NOTICE OF DECISION & Recommendation

438 Washington Subdivision

DATE ISSUED: October 9TH, 2023

Land Use Application Nos.:	WLD-2023-002 (Consolidated Application) ❖ Preliminary Subdivision ❖ Minor Variance (Lot Width – 10%) ❖ SEPA Review Processing
Applicant:	Windsor Engineers Attn. Dan Koistinen 27300 NE 10th Avenue Ridgefield, WA 98642
Property Owner:	<u>Developer/Contract Purchaser:</u> Homestead LLC Attn. Roger Foley PO Box 255 Yacolt, WA 98675 <u>Underlying Property Owner:</u> R. Scott Brunson and Karla Brunson 580 Aspen Avenue La Center, WA 98629
Site Location:	438 Washington Street, Woodland, WA 98674
Parcel & Size:	50339, 0.93 Acres
Zoning Designation:	Low Density Residential (LDR-6, Approx. 7 units/acre)
Date Application Received:	June 29th, 2023
Notice of Application & Likely DNS issued:	September 12 th , 2023 [See: case # WLD-2023-002]

SITE PLAN

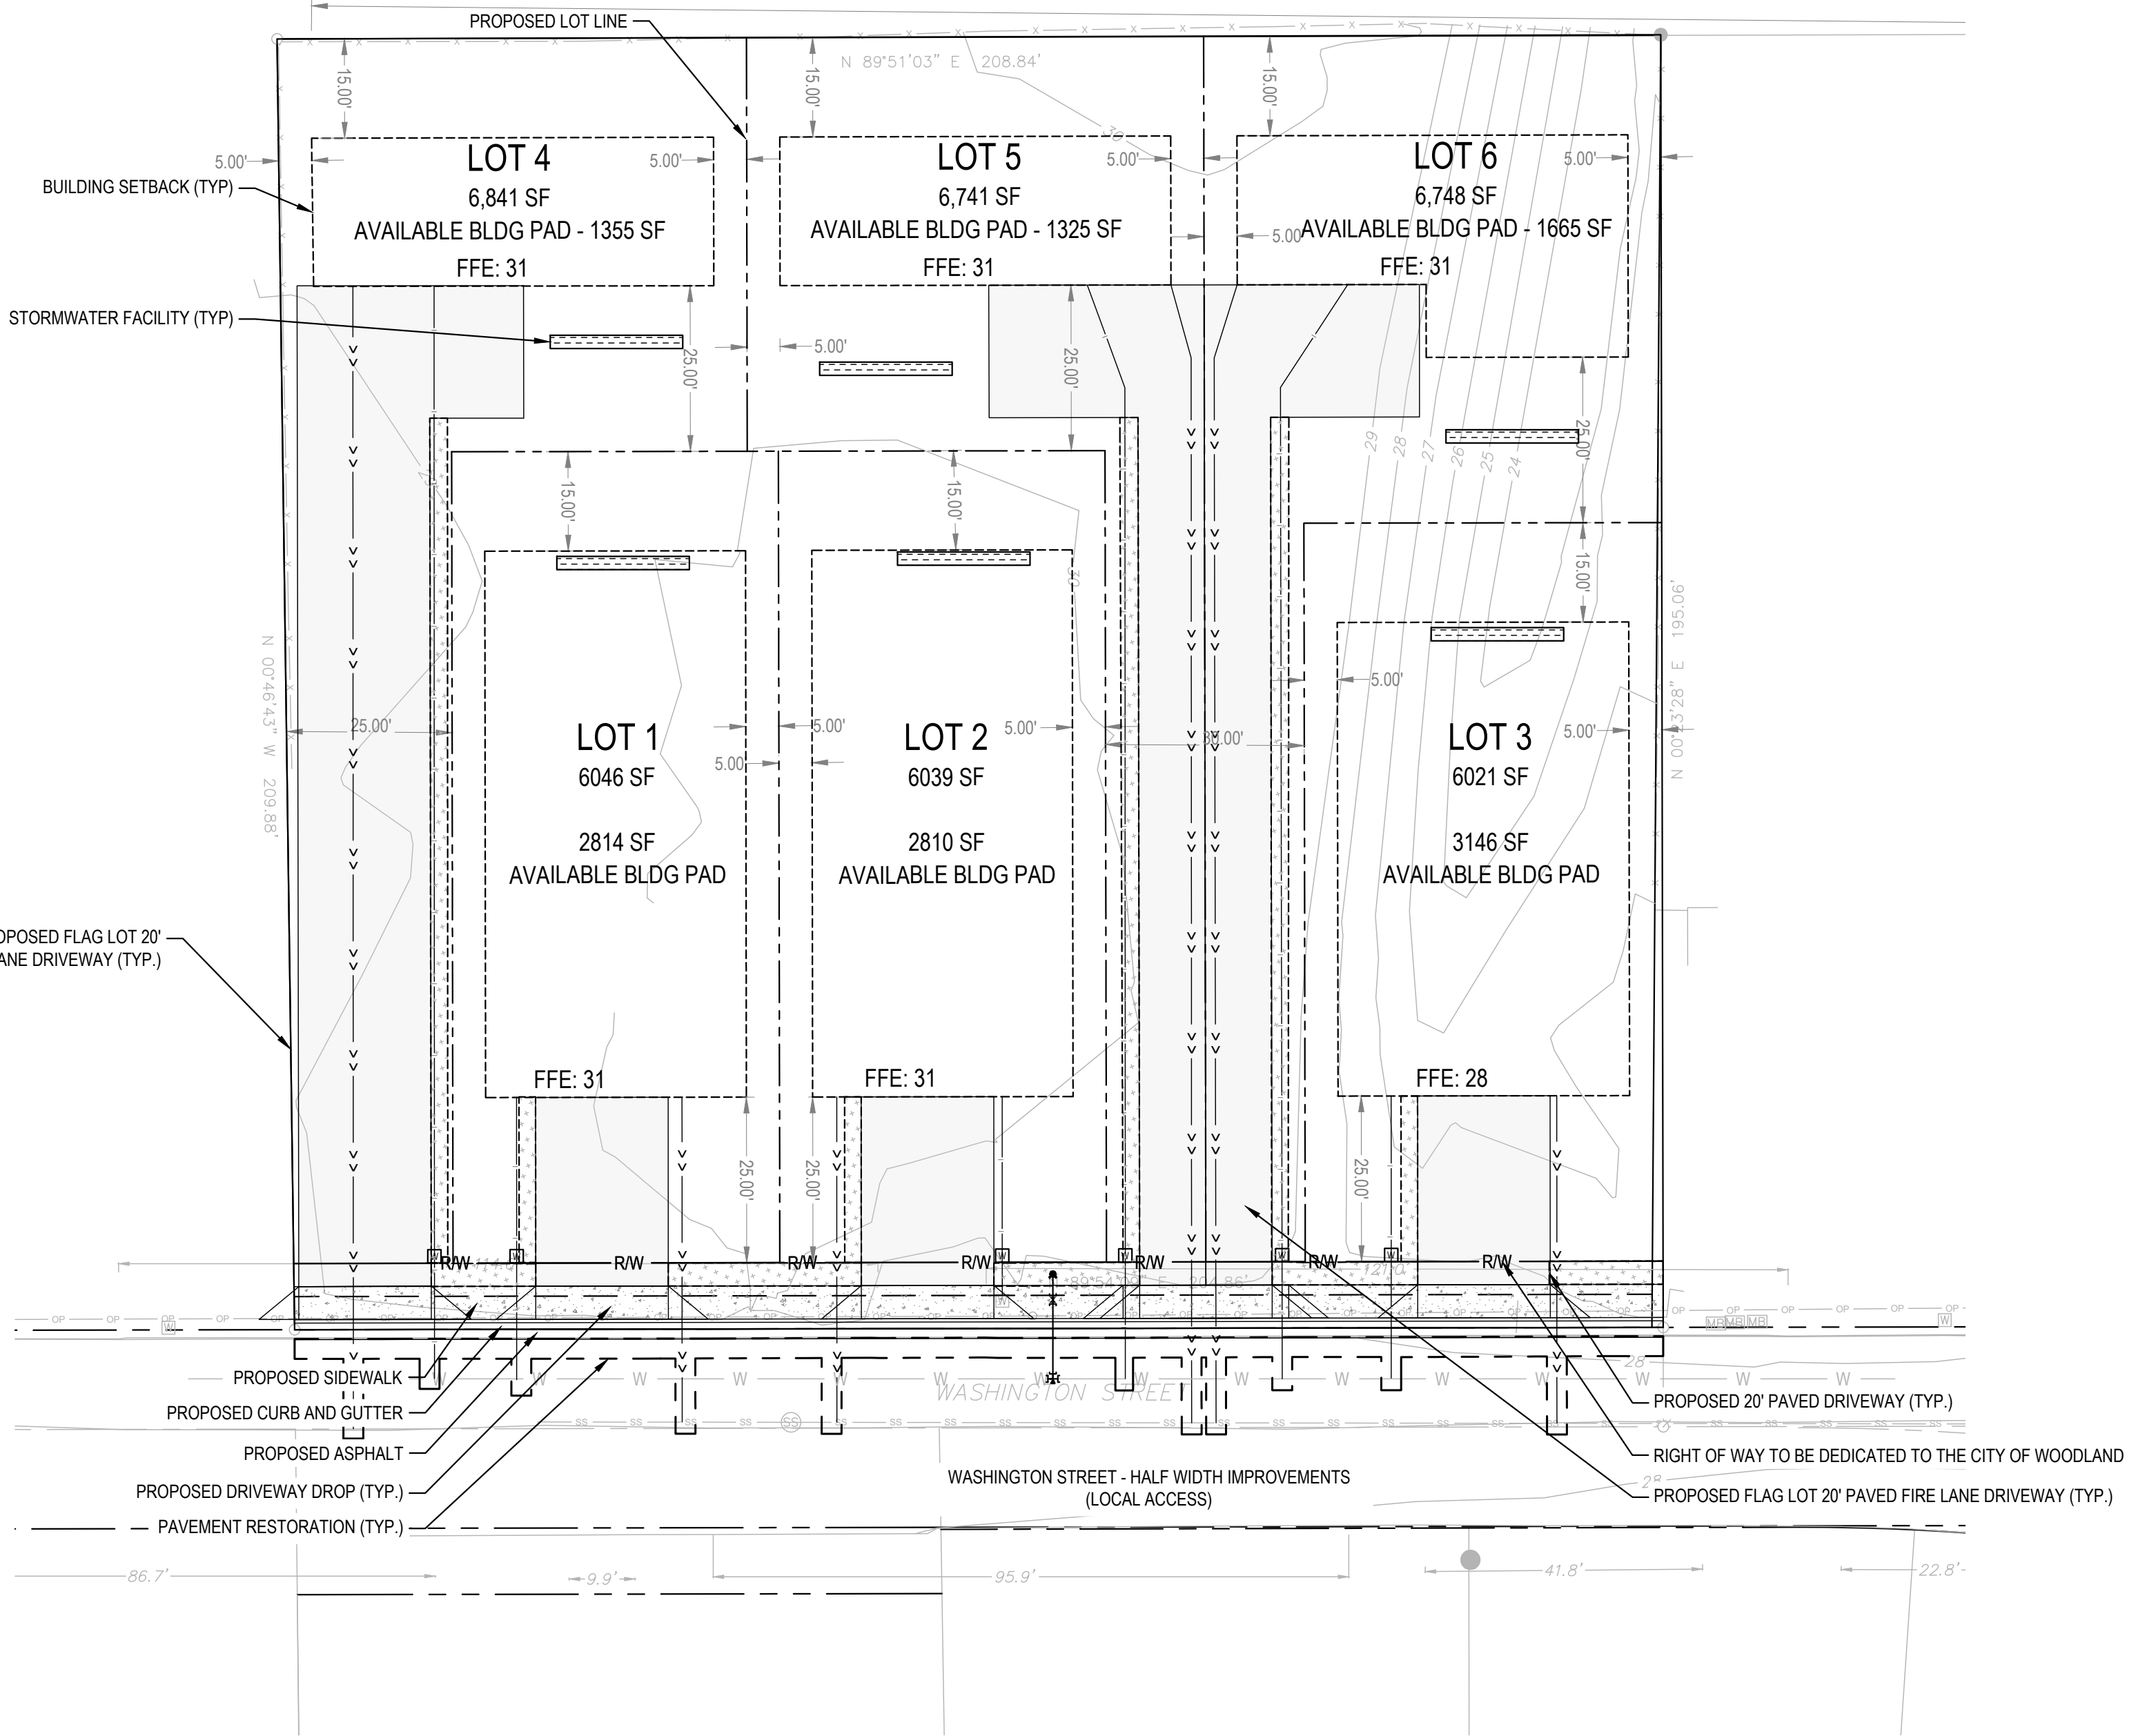
Finding 54: As shown on the preliminary site plan, the proposed Minimum 5-foot side yard setbacks shown on site plan are ok. A condition of approval has been added that Any reductions of side yard setback to less than 5-feet will require IRC Sec 302 Fire-Resistant Construction code requirements to be met. *(See Condition #10)*

FIRE RESPONSE PLAN

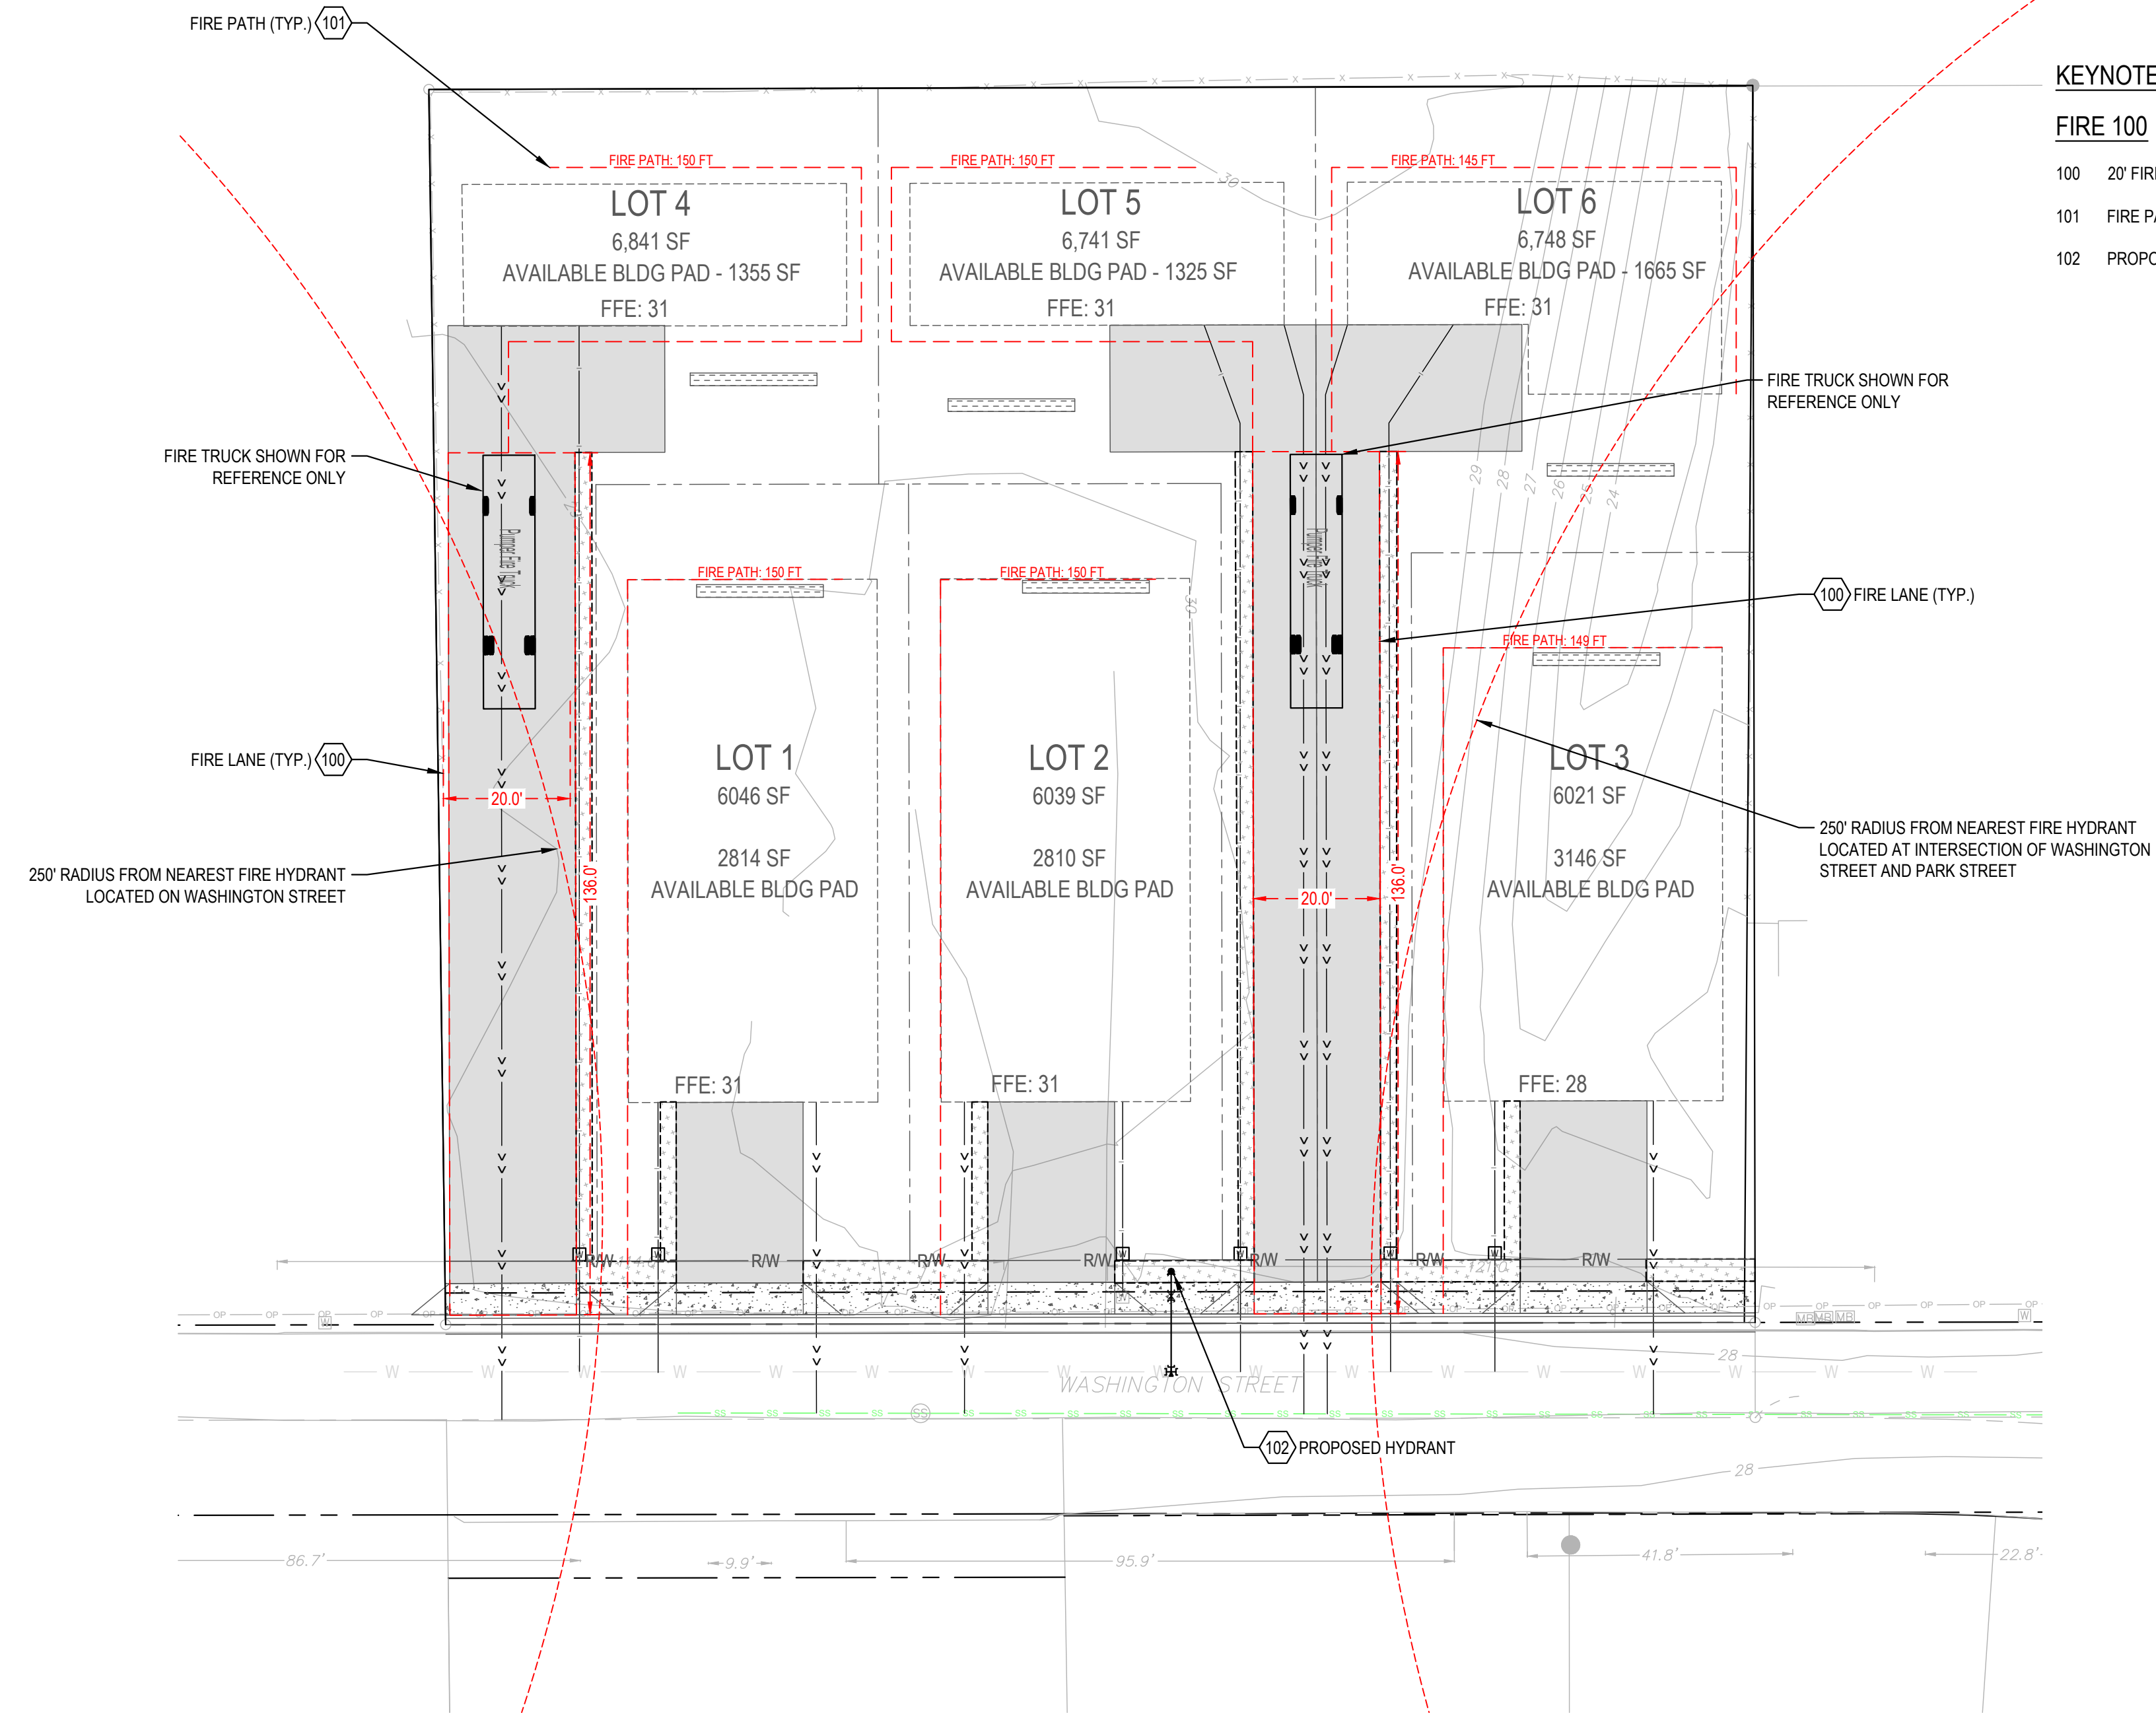
- That the proposed driveway(s) to the three proposed rear lots (lots 4, 5, and 6) did not meet the minimum 20 foot clear width roadway to meet appendix D of the Fire Code, and that any required access road with a dead end longer than 150 feet required and approved turn-around;
- That the three rear lots would be considered flag lots and be required to be sprinklered, and that plans for these sprinkler systems would require additional review and/or permitting by CCFR; and
- That the partial hammerhead turnarounds located on the three rear lots did not meet the standards within appendix D of the 2018 Washington State Fire Code.

As the project did not meet the International Fire Code, CCFR requested that the applicant make the necessary modifications to address their concerns and resubmit the revised plans for fire and life safety review. A condition of approval has been added that a note be added to the final plat stating the lots four, five, and six of the proposed subdivision require the installation of a fire suppression system (sprinklers) for every structure associated with those lots. (*See Condition #1.f*)

To address the comments, the applicant proposed shifting the access driveway to 'lot 4' of the proposed subdivision to the western edge of the development and making other general modifications to the layout to accommodate the necessary changes.

- a. The final plat shall reflect the modifications made in response to Clark-Cowlitz Fire Rescue's preliminary comments, as drawn within the updated site plan/preliminary plat dated 10/04/2023.
